SERVICE LETTER

RUNNING MODIFICATIONS ON CARBURETORS FOR ROTAX® 2-STROKE UL AIRCRAFT ENGINES SL-2ST-005

- Running modification on carburetors for ROTAX® 2-stroke UL aircraft engines.

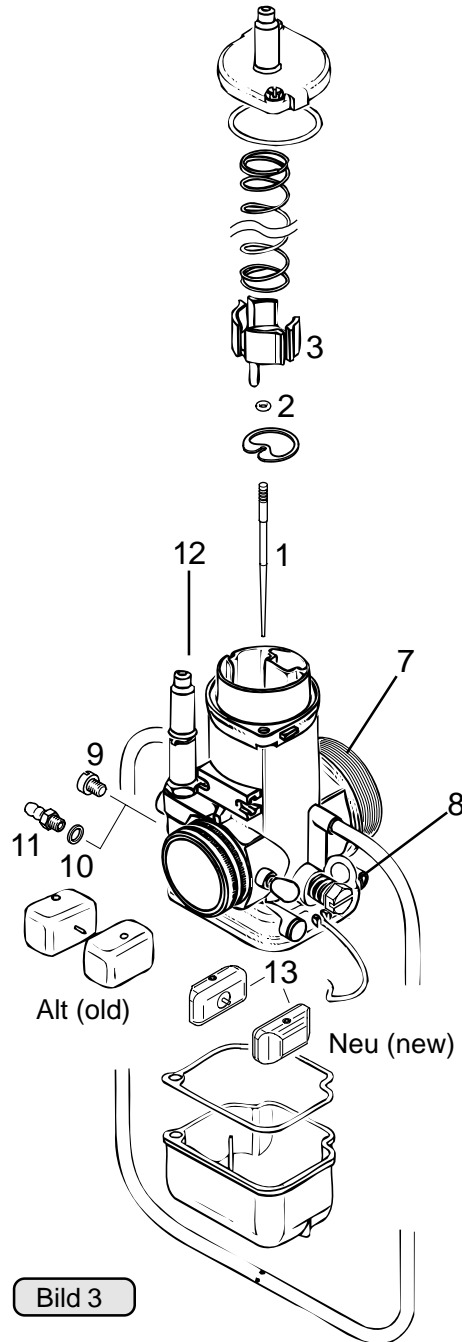
- Damping of jet needle (1) against vibration by additional O-ring (2) 2,5x1,5 (see fig. 1).
- **NOTE:** This O-ring can be installed on older carburetors only if a new spring cup (3) is fitted, as for the additional O-ring a recess (4) in the spring cup is necessary.
- Additional bore (6) Ø 2 mm in the cast fin for wire securing.

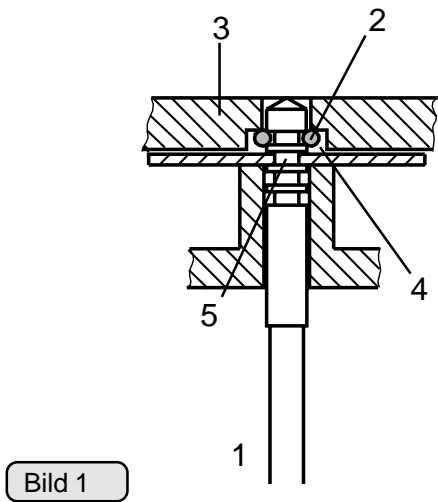
- The suction side carburetor flange (7) is furnished with a thread groove to increase the hold of the intake system (airfilter, intake silencer etc.). See fig. 3.
- The idle air regulating screw (8) is provided with a hexagon head (wrench 13 mm) instead of knurled head. See fig. 3.

- All new carburetors have a depression connection for the high altitude kit (HAC kit). See fig. 3.

◆ **NOTE:** Normally this connection is plugged with a screw (9) M6x5. If the HAC kit is to be connected, this screw is replaced by the sealing ring (10) and hose nipple (11).
